Re: Florida Power & Light Company
Proposed Turkey Point Units 6 and 7
Docket Nos. 52-040 and 52-041
Response to NRC Request for Additional Information Letter No. 040 (eRAI 6006)
SRP Section - 02.05.04 Stability of Subsurface Materials and Foundations

L-2011-552
10 CFR 52.3

NRC RAI Letter No. PTN-RAI-LTR-040

SRP Section: 02.05.04 - Stability of Subsurface Materials and Foundations

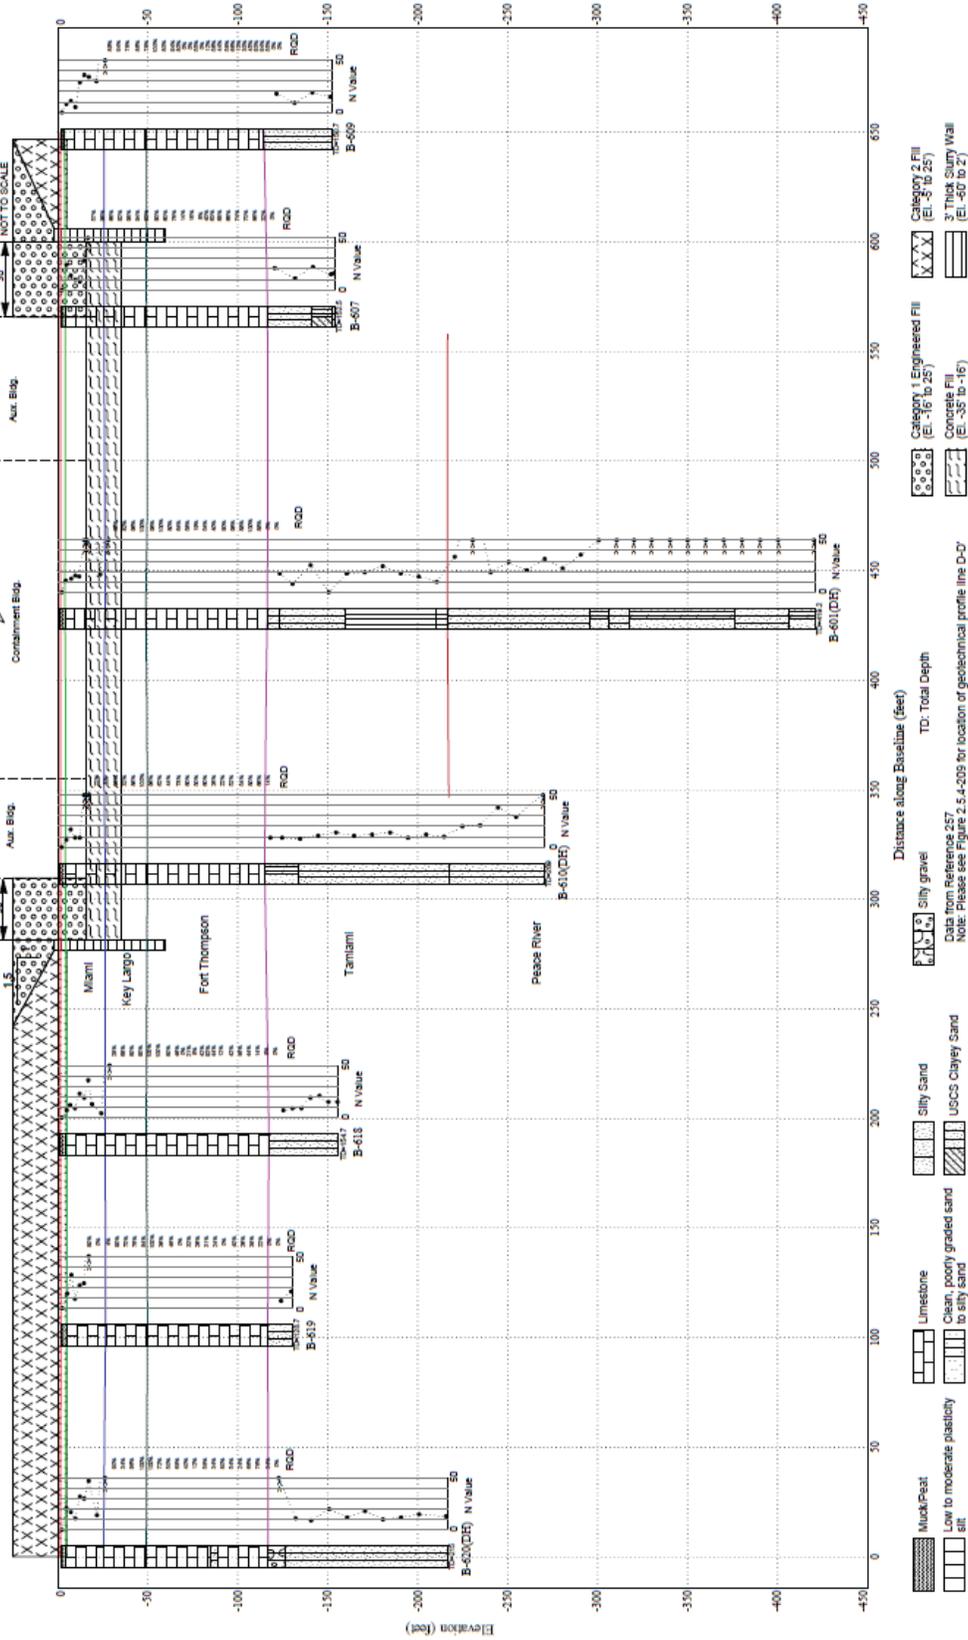
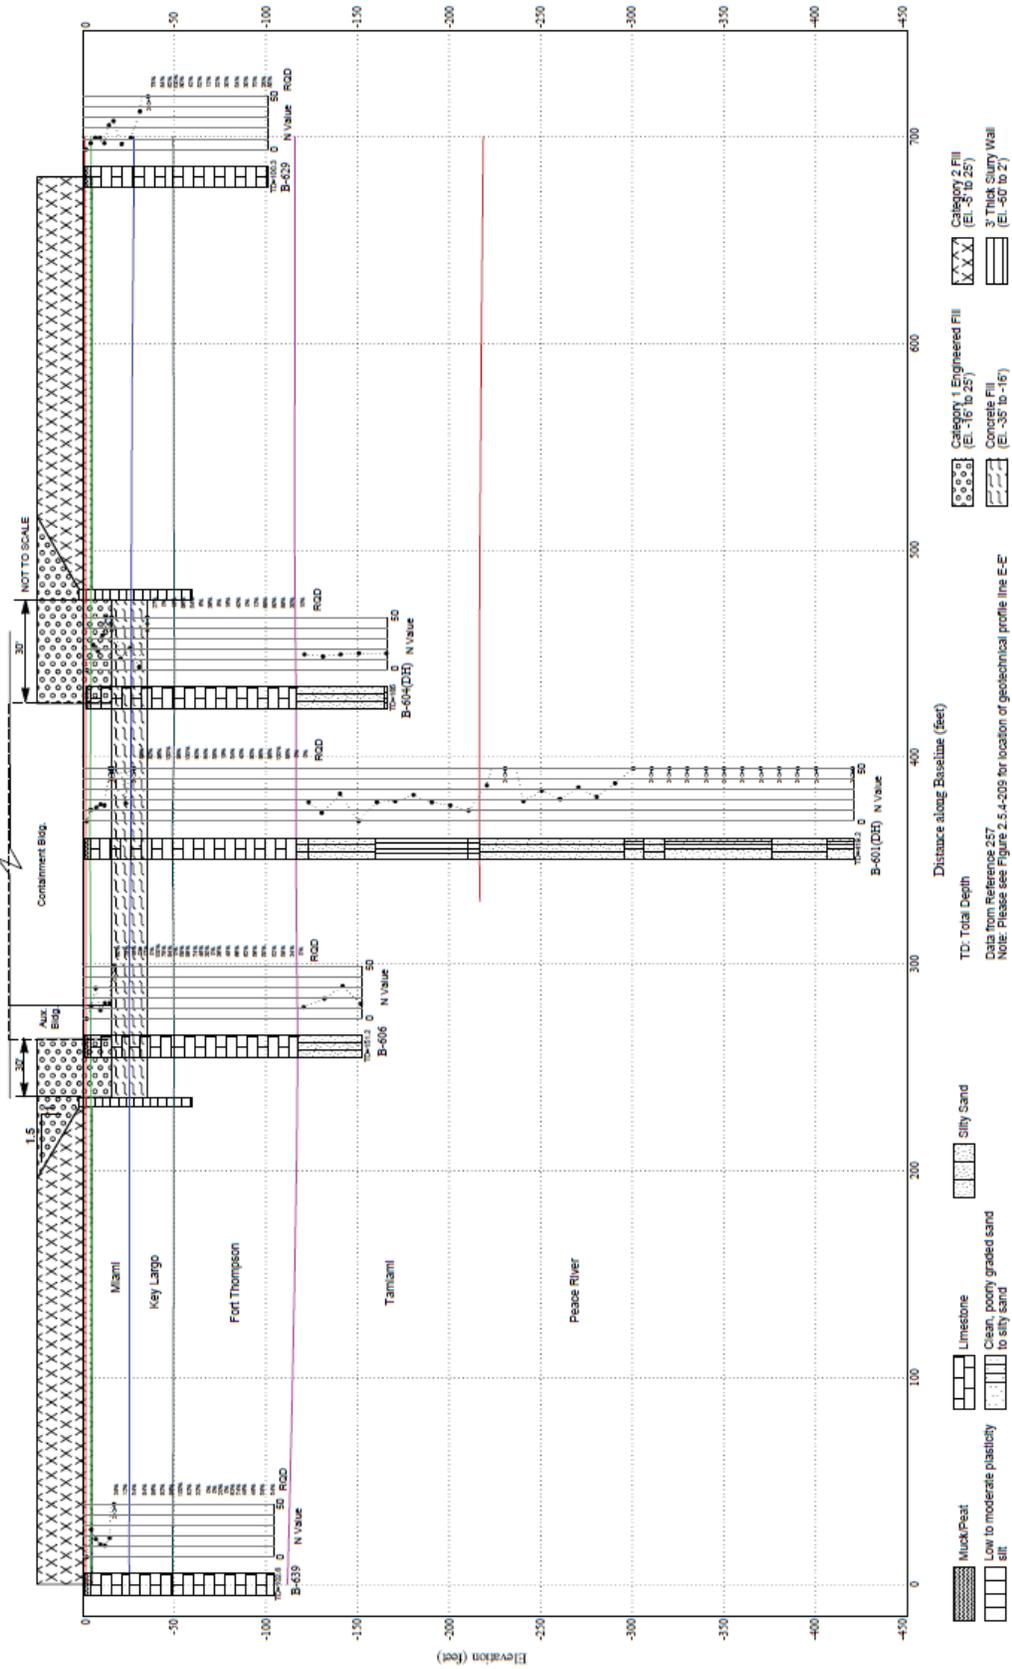
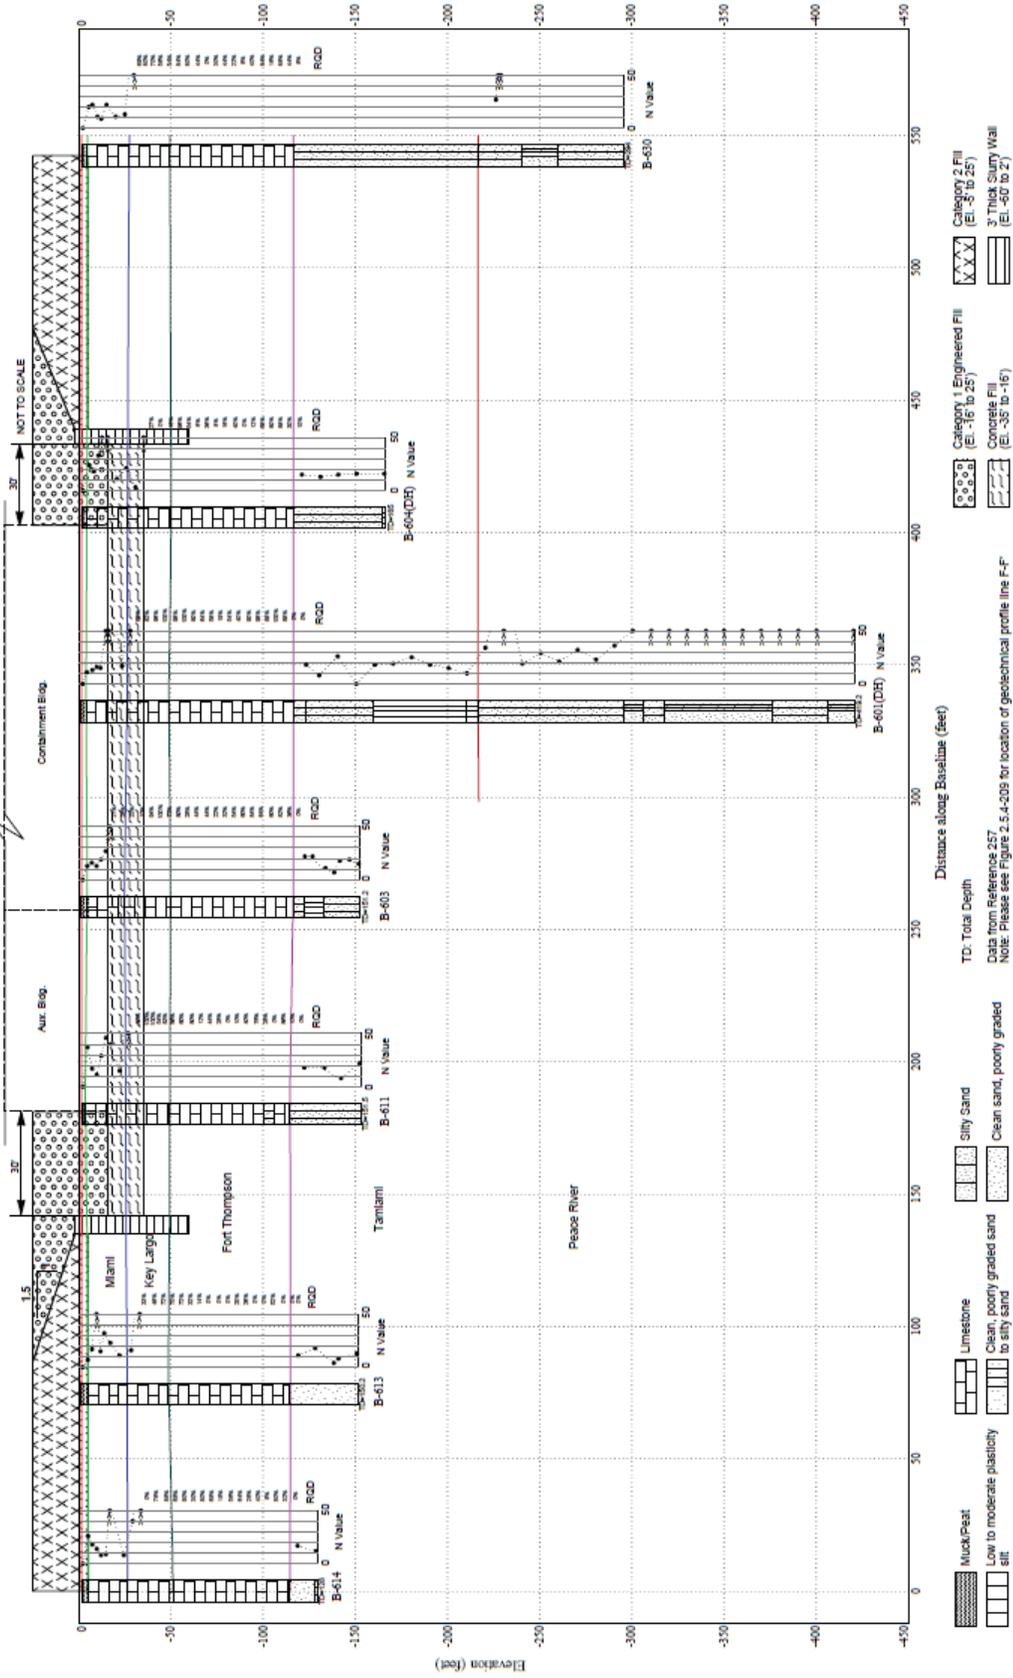
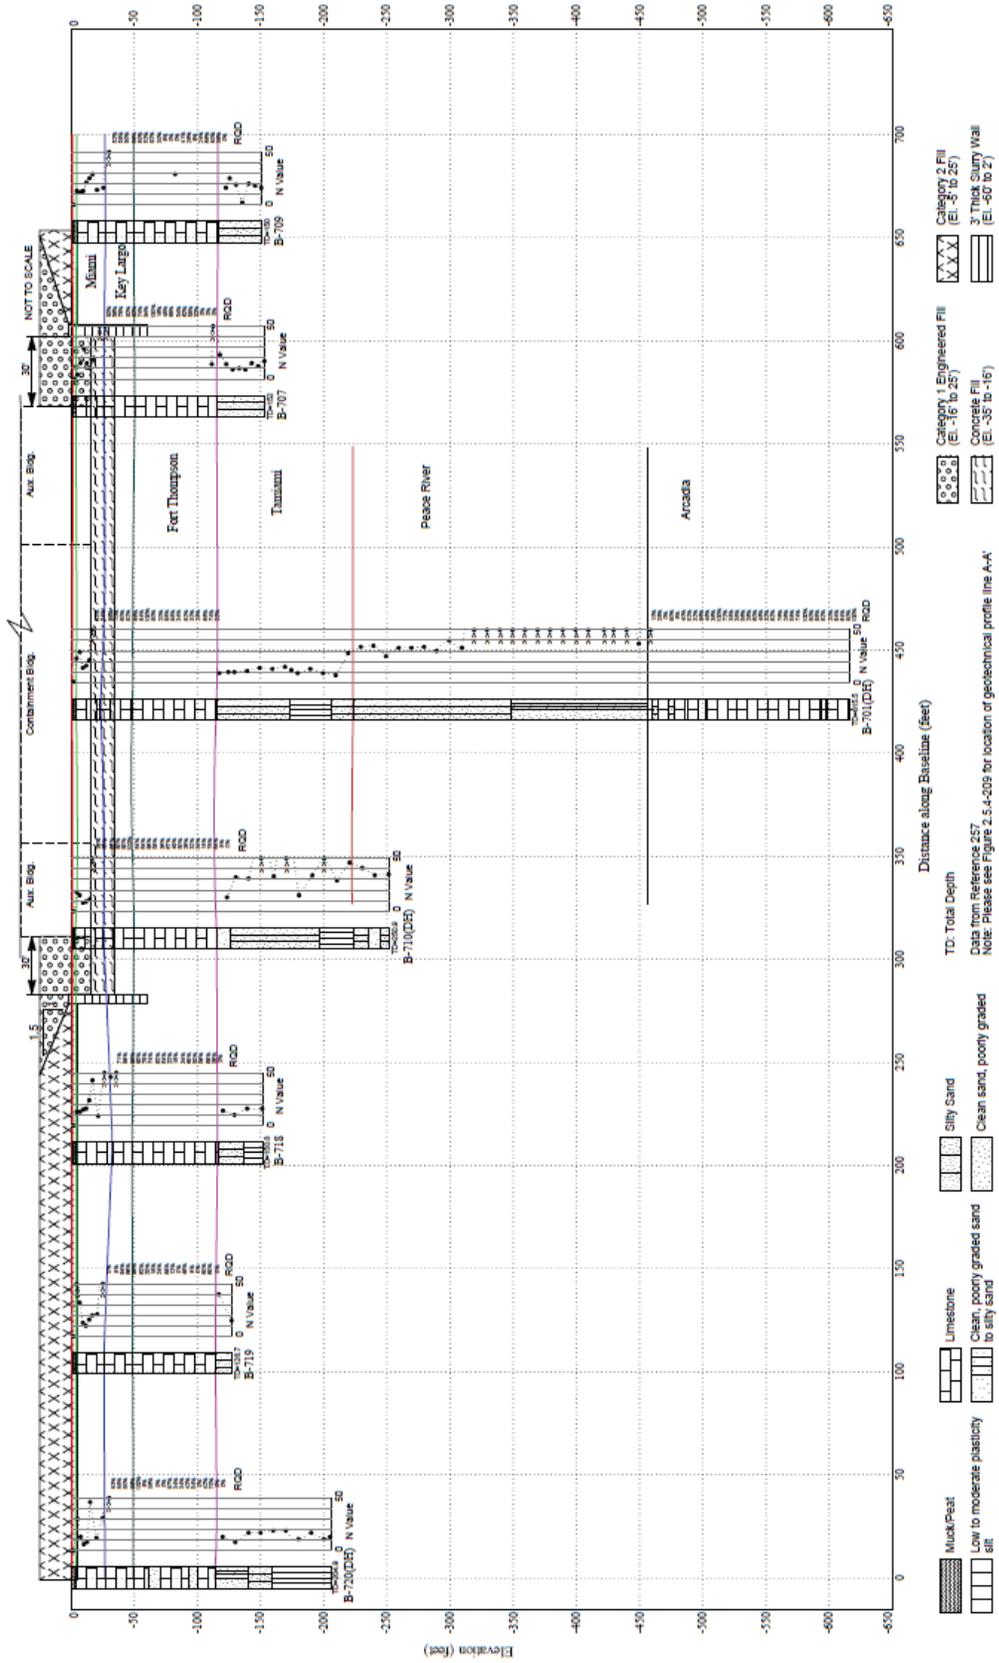
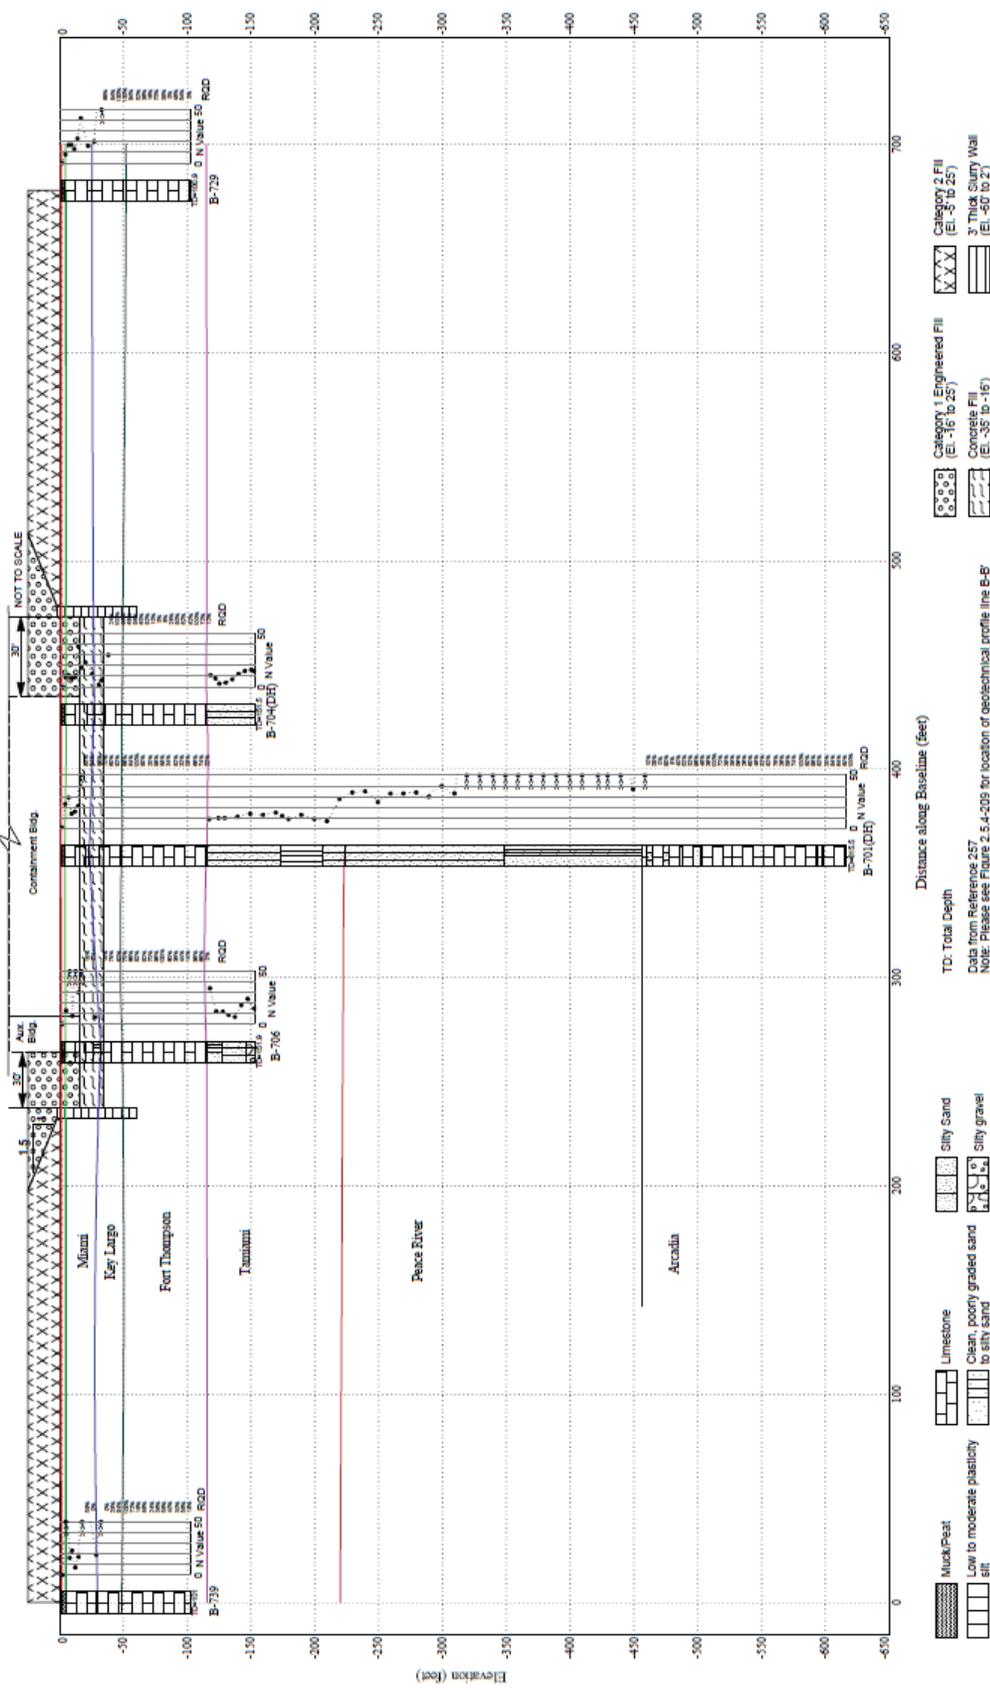
FSAR Figures 203 through 209 indicate one boring for each of the two Units extending to a depth of about 450'. Most other borings taken at the site extend to depths of only about 150'. Figure 2.5.4-220 presents information on shear wave velocity, including best estimate (BE) and upper/lower bound (UB/LB) values down to a depth of about 600'. In accordance with NUREG-0800, Standard Review Plan, Chapter 2.5.4, "Stability of Subsurface Materials and Foundations," please indicate how you estimated variations in shear wave velocity based on only two readings over the deeper portion of the profile.

FSAR Figure 2.5.4-222 shows a general conceptual excavation cross-section. In accordance with NUREG-0800, Standard Review Plan, Chapter 2.5.4, "Stability of Subsurface Materials and Foundations," please describe the procedures that will be followed during site excavation and construction activity to ensure that the appropriate strata for the proposed foundation locations are confirmed through objective measures and the exposed foundation laying surface is uniform. Also, please provide the vertical and horizontal extent of all seismic categories I excavations, fills, and slopes, including the locations and limits of excavations, fills, and backfills on plot plans and geologic sections and profiles.

The profiles from the power block subsurface investigation (refer to FSAR Figures 2.5.4-203 through 2.5.4-208) show that the subsurface strata to support foundations are relatively horizontal. However, it should be noted that the extent of excavation to final subgrade and/or to final over-excavation level is determined during construction. This determination is based on observation of actual subsurface conditions encountered, and their suitability for foundation support.

Revised FSAR Figures 2.5.4-203 through 2.5.4-209 will be included in a future FSAR revision to show vertical and horizontal extent of excavations, fill locations and slopes. Note that dimensions and slopes on figures as shown are preliminary pending final design
